California High-Speed Train Project

Request for Proposal for Design-Build Services

RFP No.: HSR 11-16 Addenda Change Log for

Addendum No. 3

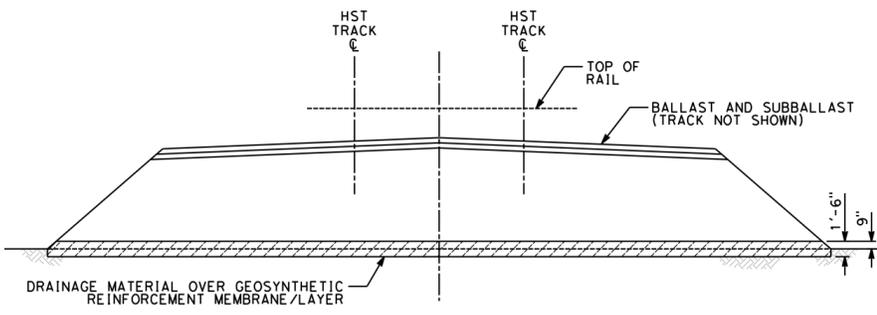
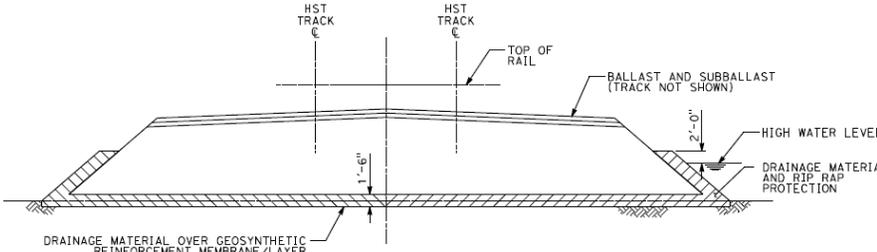
Change No.	Description	Location
23	<p>10.8.5.2 Embankments in Wet Conditions / 10.8.5.3 Embankments in Flood Plains</p> <p>1. Changed Title of Figure 10-2 from: <i>"Drainage Layer under Embankments in Floodplain"</i> to: <i>"Earthwork Embankment in Wet Conditions"</i></p> <p>2. Corrected Figure 10-2. See Figure below for correct image:</p>  <p>3. Changed Title of Figure 10-3 from: <i>"Earthwork Embankment in Floodplain / High Water"</i> to: <i>"Drainage Layer under Embankments in Floodplain / High Water"</i></p> <p>4. Corrected Figure 10-3. See Figure below for correct image.</p> 	B3 - Pt C.1, Page 10-26 and 10-27

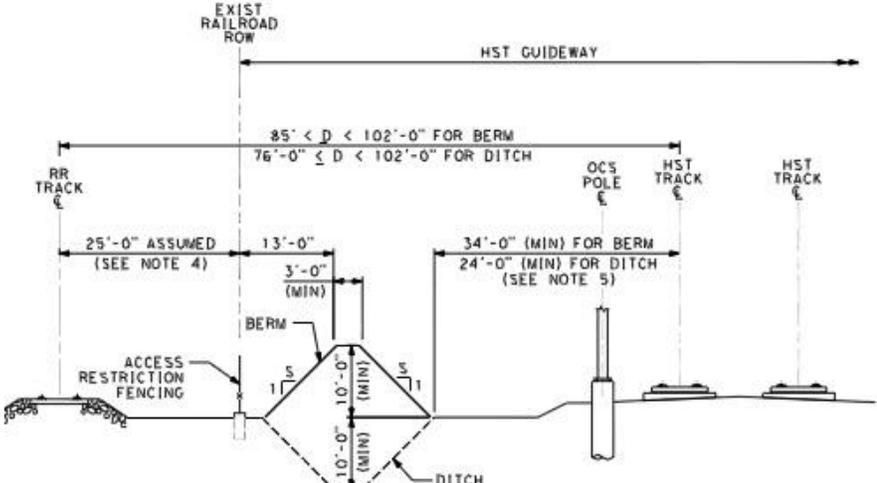
Change No.	Description	Location
1	File name changed to reflect move from Book 4 to Book 3. New file name is AD.2 B4 – Pt B.4 – Design Variance Report.pdf	B3 - Pt D.5
2	The following documents were added to the Design Variance report, and the Table of Contents has been updated to reflect these additions: <i>Horizontal Clearance To Union Pacific Railroad Right Of Way</i> <i>Vertical Element Lengths Within Fresno Trench</i> <i>Dry Creek Structure Clearance</i>	B3 - Pt D.5, Page i

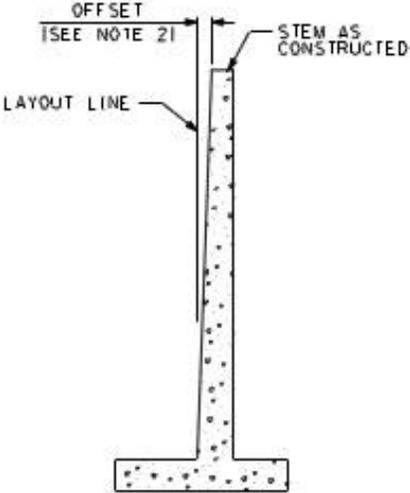
Change No.	Description	Location
1	<p>Directive Drawing DD-IP-001</p> <p>Added Note #6: <i>"6. BERM MATERIAL AND COMPACTION SHALL BE SIMILAR TO EMBANKMENT."</i></p>	B3 - Pt E.1, Page 37 of 74
2	<p>Directive Drawing DD-IP-005</p> <p>Revised Typical Section for Earthen Berm or Ditch; Distance range (for berm) btwn RR Track centerline and HST Track centerline revised from $86'-0" \leq D < 102'-0"$ FOR BERM to $85'-0" \leq D < 102'-0"$ FOR BERM</p> 	B3 - Pt E.1, Page 41 of 74
3	<p>Directive Drawing DD-IP-005</p> <p>Added Note #6: <i>"6. BERM MATERIAL AND COMPACTION SHALL BE SIMILAR TO EMBANKMENT."</i></p>	B3 - Pt E.1, Page 41 of 74
4	<p>Directive Drawing DD-ST-014</p> <p>Remove wall offset value table; added note #2 text to offset dimension</p>	B3 - Pt E.1, Page 59 of 74
